Rozelle Interchange AQCCC

Meeting 2

16 November 2021

Additional questions

Figure 8-78 Contour plot of change in annual mean PM_{2.5} concentration in the 2033 cumulative scenario (2033-DSC minus 2033-DM)

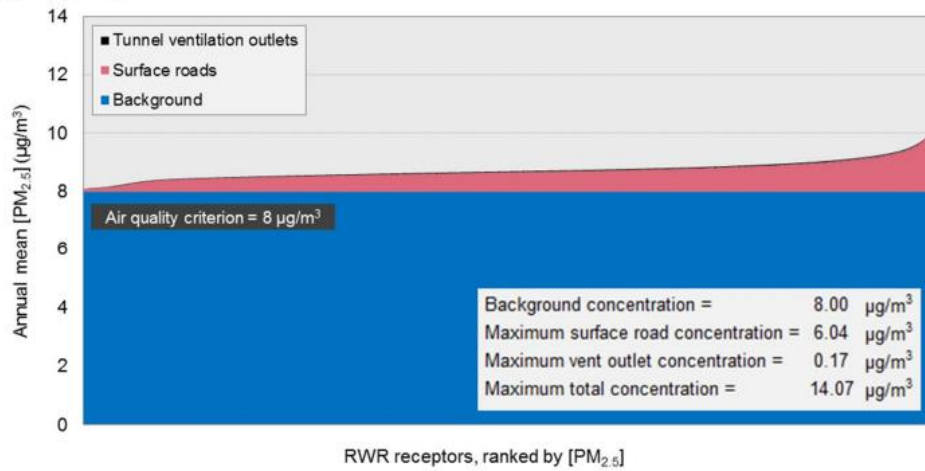
Does the air quality modelling identify locations that will be negatively impacted and those that benefit from either change in traffic volumes or AQ?

The air quality modelling identifies locations in the local vicinity of the outlets that will be impacted by changes in traffic and air quality as a result of the project.

An example of this is shown in Figure 8-78 from the EIS. In this figure, one of many modelled scenarios, the green shading indicates an improvement in maximum 24-hour PM_{2.5} concentrations due to the project, while the purple where maximum 24-hour PM_{2.5} concentrations increase due to the project.

The changes due to the project seen in the figure are all resulting from changes in surface road traffic. The outlets are designed to disperse pollutants and are very effective in this task such that ground level impacts are too small to be measured

Figure 8-74 Source contributions to annual mean PM_{2.5} concentration at RWR receptors (with-project and cumulative scenarios)

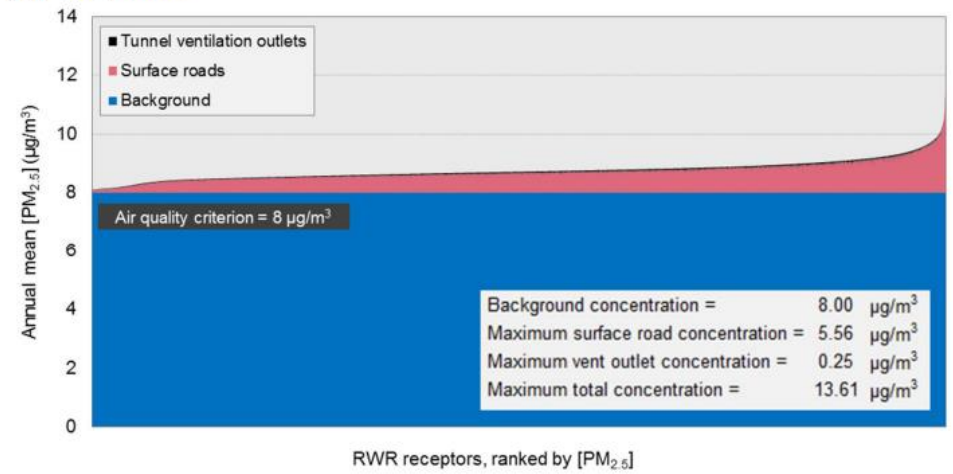
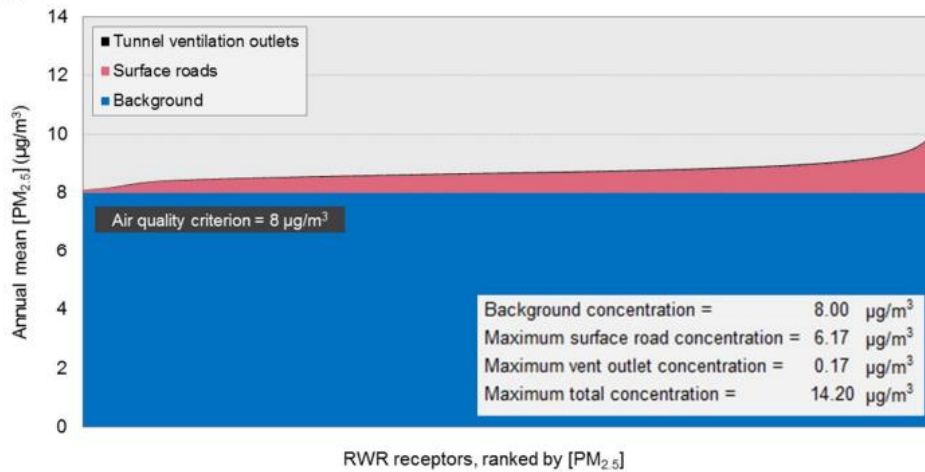
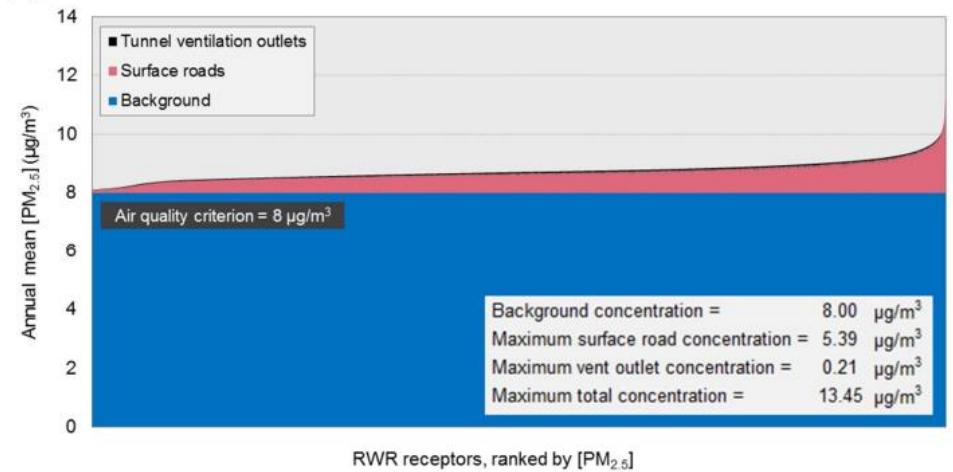
How does the tunnel AQ approval limits compare to other tunnels built over the past 20 years across Australia, Europe, USA, UK? At the very minimum, all the tunnels built in Sydney over the past 20 years.

WestConnex tunnels have some of the most stringent in-tunnel air quality criteria in the world. These criteria have become tighter over time and are more stringent than older tunnels in Sydney eg Lane Cove Tunnel and Cross City Tunnel. Outlets have been designed so that there is a general improvement in air quality due to a reduction in surface traffic and more efficient vehicle operation within the tunnels.

For example, figure 8-74 below from the EIS demonstrates the minor contribution made by the outlet emissions (thin black line on the top) when viewed against the background (blue) and modelled surface contribution from roads (red).
